**STATEMENT
of
KASSEL PRINCE, P.Eng., PMP**

**In Relation to:
105 Wells Hill Avenue, City of Toronto
Committee of Adjustment Minor Variance Hearing
File No. A1156/18TEY)**

**Nicholas Saint-Martin and Danielle Gutstein
(Also referred to herein as “the Clients”)**

February 12, 2019

Parking Demand Analysis (Worst Case) – Tedesco Engineering

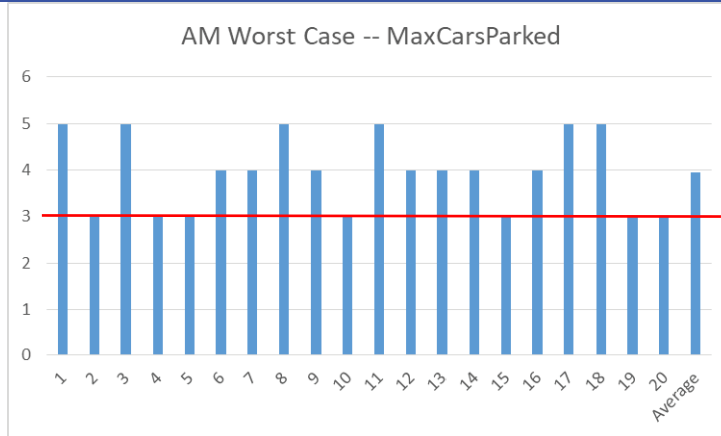
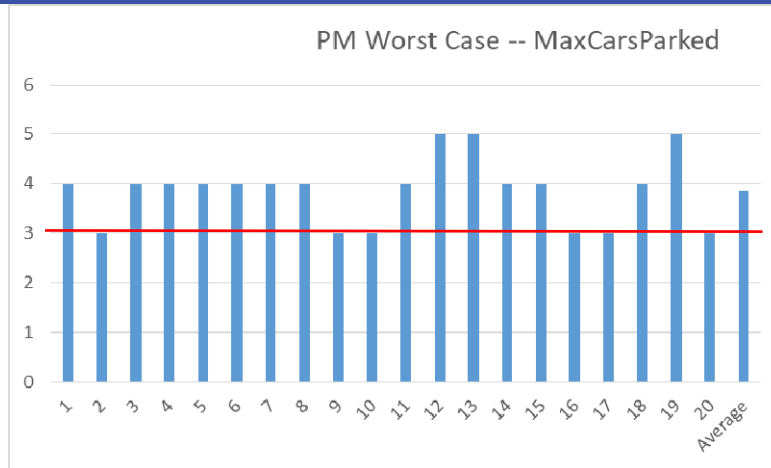
3.10 Given the likelihood that PUDO dwell times have been understated, it is my opinion that the worst case scenario should be relied upon for the minimum PUDO parking requirement for the site. Simulations in Section 4.3 of the Tedesco Engineering Study shows a parking demand of four or more cars occurs on 13

of the 20 AM (65%) simulations and 14 of the 20 PM (70%) period simulations. The average of all 20 simulations shows a demand of approximately four vehicles.

Based on the Tedesco analysis, the site should provide five parking spaces to accommodate established demand; at a minimum four parking spaces for PUDO should be provided. TMIG reserves the right to comment on PUDO requirements for the site, pending revised analysis that incorporates observed dwell times from operational daycares.

- 3.15** Considering the combined AM and PM parking demand analysis conducted by Tedesco Engineering in Section 4.3 (see **Attachment A**) assuming each of the simulations represents a school day in a typical month (i.e. 20 days), even the potentially understated PUDO parking demand proffered in the report would

exceed the proposed on-site supply (3 spaces) approximately 4 days out of a 5 day school week during either the morning or evening period, irrespective of the duration of the overlap. This overflow demand is likely to promote:

- vehicles stopping on the driveway blocking other vehicles from exiting, requiring the vehicle stopped on the driveway to reverse onto Wells Hill Avenue to clear the blockage (unsafe due to geometry of the roadway and limited sight lines),
- on-street parking by parents along Wells Hills Avenue, which may impact traffic flow, sight lines and general safety in the vicinity of the site access, or
- vehicles waiting in the travel lane to enter the driveway and PUDO area, whilst allowing on-site vehicles to clear thereby causing congestion / blockage of the travel lane. Queues created due to this blockage may also impact the operation of the St. Clair West and Wells Hill Avenue intersection.

- 4.5** It is my opinion that provision should be made to accommodate the vehicular accumulation levels identified within the Tedesco report reflected for the “Worst Case” conditions. This means that 5 parking spaces should be provided to accommodate an acknowledged level of PUDO activity.
